SAFETY EVALUATION BY THE OFFICE OF NUCLEAR REACTOR REGULATION

LONG-TERM HYDROGEN MONITORING CAPABILITIES AND RELIEF REQUESTS

ARKANSAS NUCLEAR ONE, UNIT NOS. 1 AND 2

DOCKET NOS. 50-313 AND 50-368

FIGURE

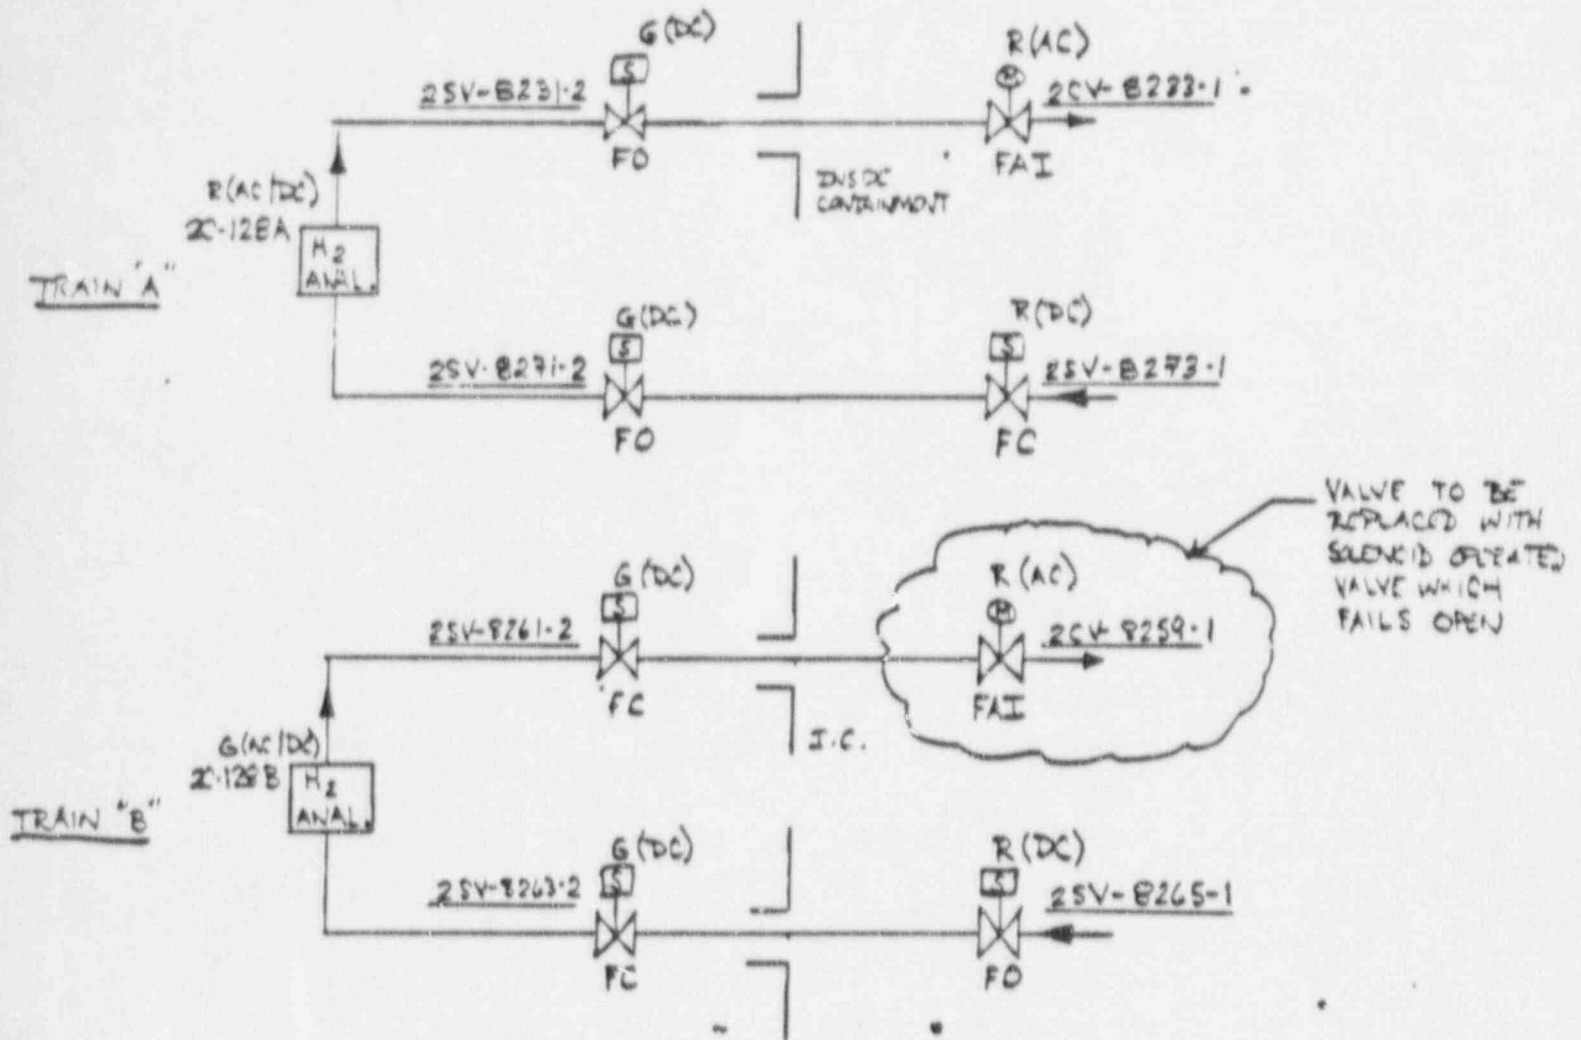
The staff has reviewed the schematic for the design change and agrees with the licensee that the containment isolation capability (as required by 10 CFR Part 50, Appendix A, Criteria 54 and 56) is not jeopardized by the valve replacement because containment isolation could still be achieved by the existing redundant isolation valve located outside containment, which is powered by "green" DC power. Although containment isolation reliability is reduced somewhat by replacing a fails-as-is valve with a fails-open valve, containment isolation integrity is still assured by the redundant valve in this line (as it is in all four lines) in that, despite any single active failure, each line will still isolate. This arrangement is in accordance with SRP 6.2.4, paragraph 6.j.

- No concerns regarding containment isolation capability
- Failure modes 1,2,3,5,6,7 & 8 will always result in at least one channel operable
- Problem is with failure mode 4, delayed failure of red AC results in "B" loop flow not being available with the "B" H₂ analyzer cabinet functional (also "A" loop analyzer cabinet would not be functional)

The staff concludes that the slight reduction in containment isolation reliability caused by the above modification is acceptable since it provides for an increased availability for monitoring hydrogen. The staff, with consideration of the costs which would be associated with system redesign, concludes that the advantages of the increased availability of hydrogen monitoring capability outweighs the disadvantages of the reduction in containment isolation reliability; therefore, the modification to the design of the hydrogen monitoring system containment isolation valves is acceptable.
